APPLICATION FOR AMENDMENT
TO
FACILITY OPERATING LICENSE NUMBER NPF-3
DAVIS-BESSE NUCLEAR POWER STATION
UNIT NUMBER 1

SAFETY ASSESSMENT AND SIGNIFICANT HAZARDS CONSIDERATION
FOR
LICENSE AMENDMENT REQUEST NO. 97-0016

Proposed Modification to the Davis-Besse Nuclear Power Station (DBNPS) Operating License NPF-3, Appendix A Technical Specifications (TS) to Incorporate a New Repair Roll Process for Steam Generator Tubes With Defects Within the Upper Tubesheet

FIGURE
TUBE REPAIR ROLL

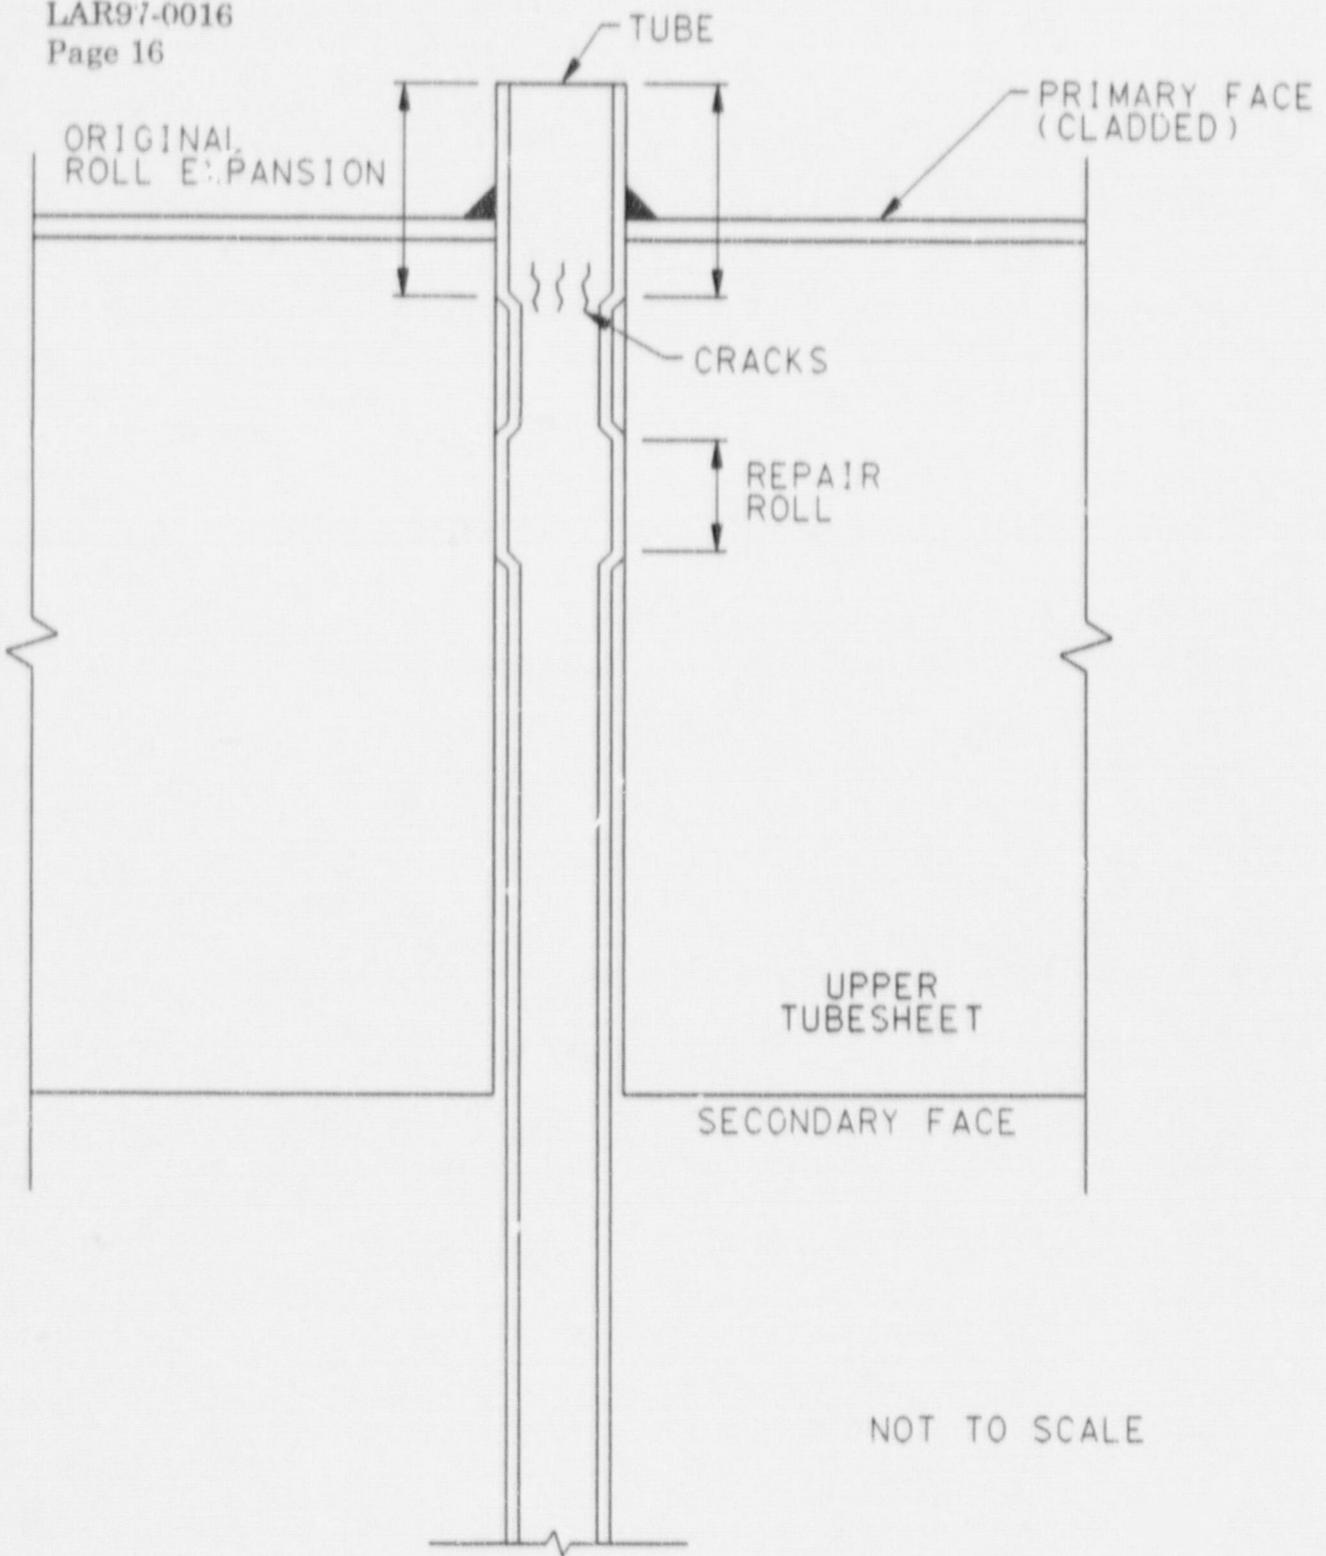
The repair roll is a process whereby a new primary to secondary pressure boundary joint is established by hard rerolling the tube closer to the secondary face of the tubesheet. The new pressure boundary joint is established to remove the area of degradation from pressure boundary service (see the attached figure). The repair roll process was qualified for Inconel Alloy 600 material tubes in the upper tubesheets by Framatome Technologies Incorporated (FTI) for Babcock and Wilcox OTSGs. The DBNPS OTSG tubes are fabricated of Inconel Alloy 600 material. Framatome Technologies Incorporated Topical Report BAW-2303P, Revision 3, "OTSG Repair Roll Qualification Report," provides the basis for the acceptability of the repair roll process resulting in a tube-to-tubesheet joint equivalent to the original construction. BAW-2303P is provided as an attachment to this LAR. The report is proprietary to FTI and is so marked. Responses to previous NRC
